ADDRESS : 305 FIELDSTONE DR SUBDIV: FIELDSTONE FARMS  
 CONTRACTOR : UPRIGHT BUILDERS PHONE : (919) 858-8383  
 OWNER : WILLIAMS PHILLIP L. & SUSAN PHONE :  
 PARCEL : 05-0635- - -0058- -17-  
 APPL NUMBER: 13-50032408 CP NEW RESIDENTIAL (SFD)  
 DIRECTIONS : T/S: 11/01/2013 09:27 AM JBROCK ----  
 401 N L ON PINEY GROVE RD NC 42 L ONTO  
 WADE STEPHENSON RD R FIELDSTONE RD TO  
 305 FIELDSTONE DR LOT 15  
 LAND NOTES : LXMN 8/02/05 SPLIT FROM THE MAIN PARCEL  
 NOTE: ALLOWABLE IMPERVIOUS SURFACE  
 COVERAGE PER LOT IS 12%

PERMIT: CPSF 00 CP \* SFD

5'-4" RETAINING WALL  
 WILLIAMS RESIDENCE  
 305 FIELDSTONE DRIVE  
 HOLLY SPRINGS, NORTH CAROLINA  
 UPRIGHT BUILDERS

RETAINING  
 WALL CROSS  
 SECTION  
 S-1  
 SHEET 1 OF 1

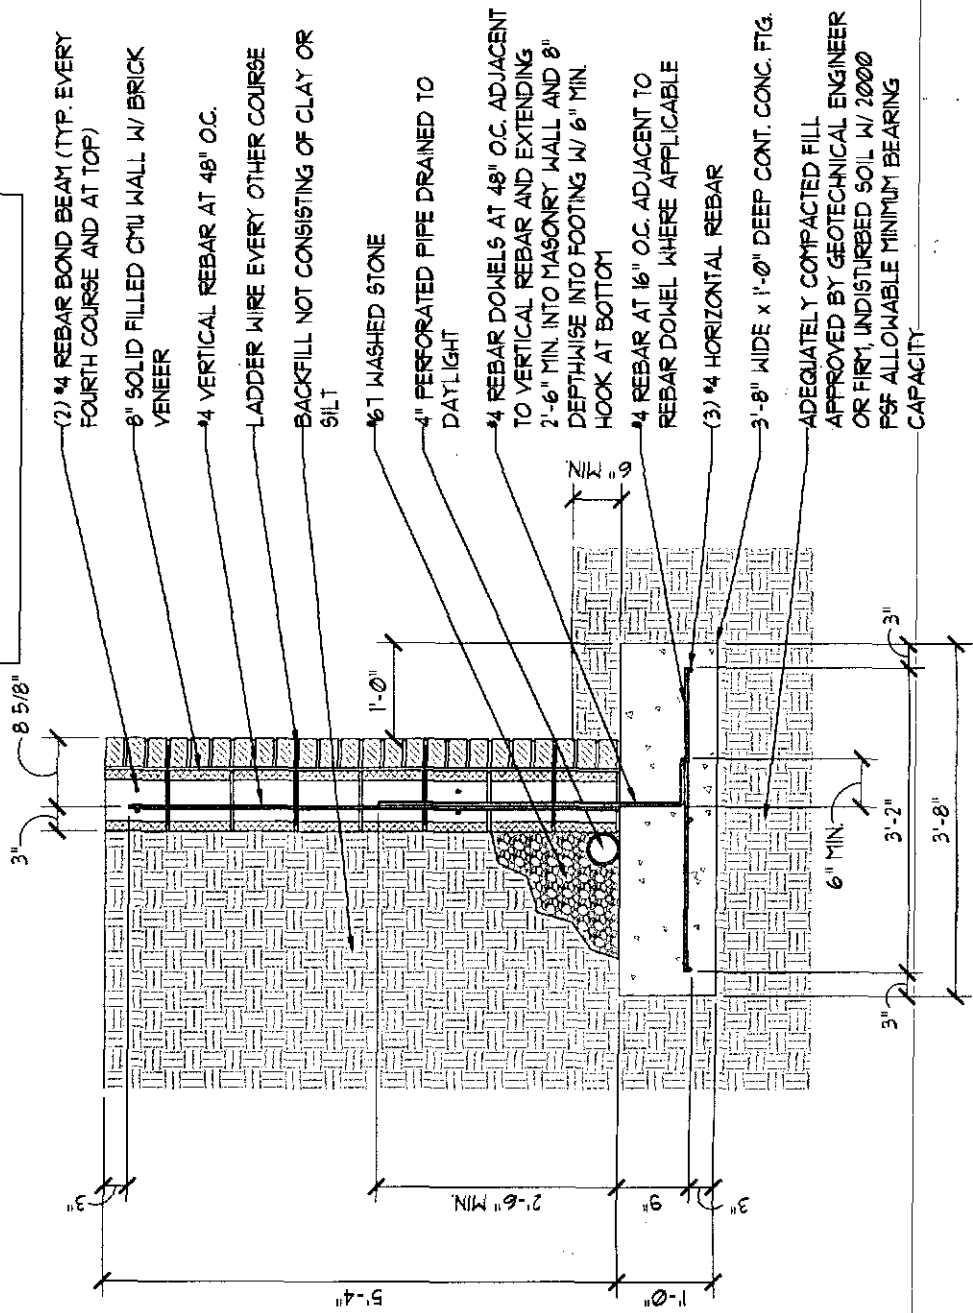
Retaining Wall behind  
 House  
 INSPECTED 7/10/14
